# Illustrated Parts List - IPL Update

**365 X-TORQ**

Description of change

## 2. Decompression valve

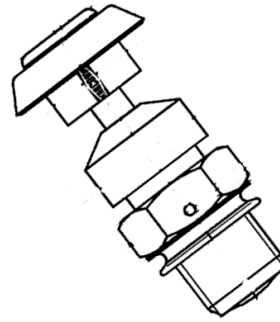
1. New Ignition module. New start curve. This update together with the new decompression valve improve startability of hot product and/or avoid misfire
2. New decompression valve to cylinder. Hole Ø1mm was Ø1.2mm
3. New tank cap and gasket. Reason is new supplier

584 28 87-01

537 29 44-01
